ANNEX B: Product Change Description

BG96 R1.1 & BG96 R1.2 **Differences Statement**

LTE Module Series

PCB Rev.: R1.2

Figure 1: Schematic Designs of BG96 R1.1 and R1.2

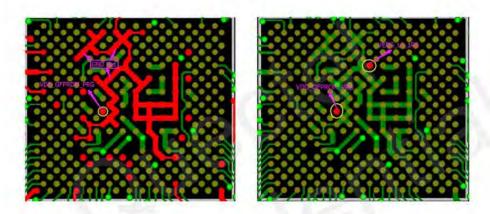
The VDD_QFPROM_PRG (N19) pin of baseband chip is for secure boot function. In BG96 R1.1, this pin is connected to ground directly, which means secure boot function is disabled.

According to Qualcomm's suggestion and our customers' requirements, the VDD_QFPROM_PRG pin is connected to VREG_L3_1P8(1.8V) in BG96 R1.2 so as to enable secure boot function.
